**ERRATA 1**  
**To**  
**SCA Security Supplement V1.0**

13 July 2001

The following changes have been authorized by the JTRS Change Control Board as approved Change Proposals 142, 380, 383, 416, 469, and 475.

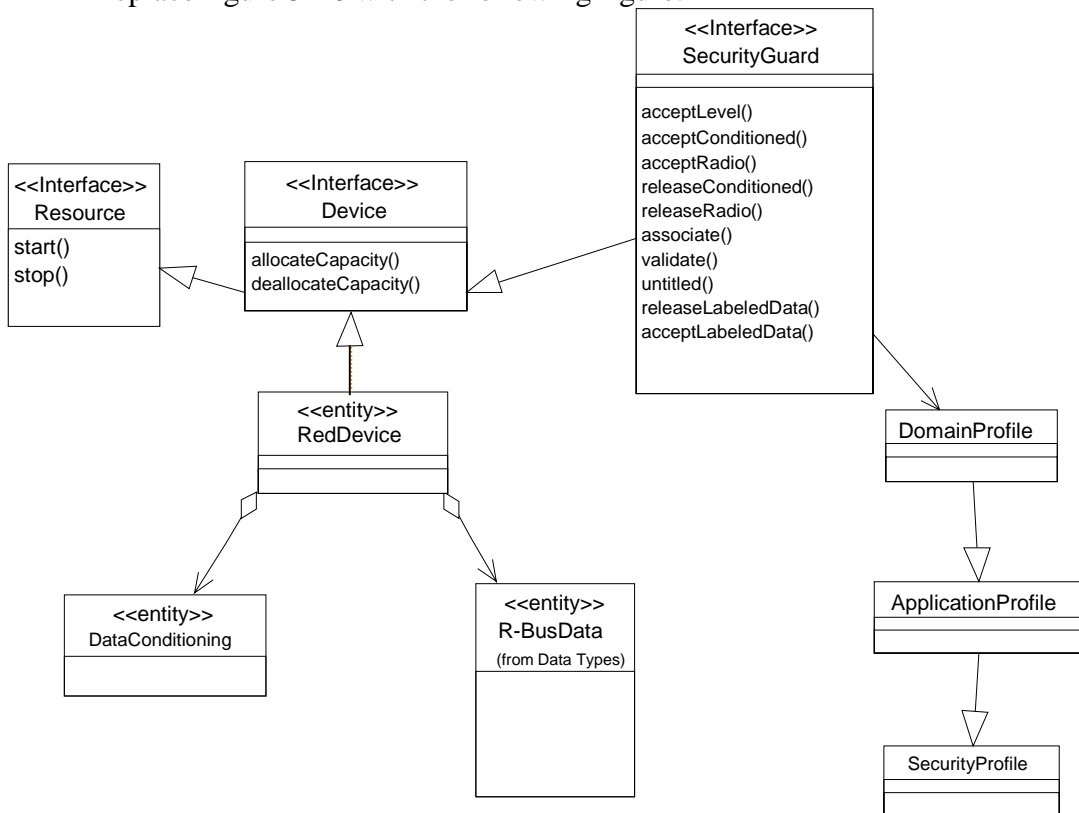
Change the list found in section 3.3.1.4 to read:

- *DomainManager*
- *Device*
- *LoadableDevice*
- *ExecutableDevice*
- Domain Profile
- *ApplicationFactory*
- *ResourceFactory* (optional)
- Audit
- *FileSystem*
- *FileManager*

replace figure 3-16 with the following figure:

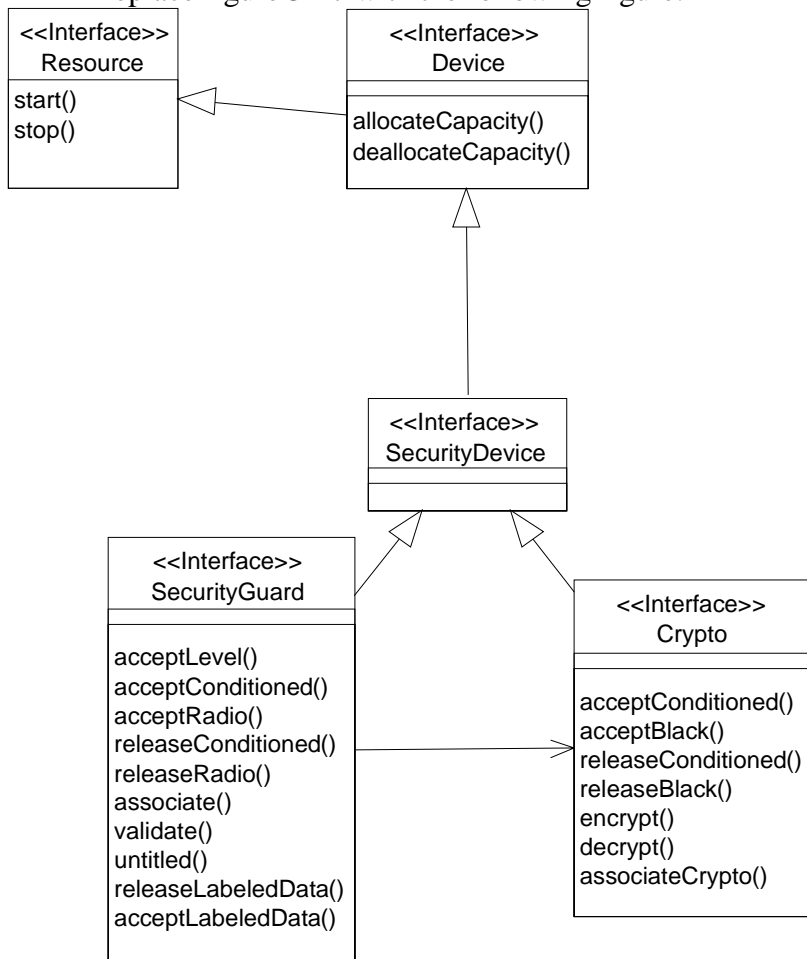
Change the following two figures in section 3.6.4.2:
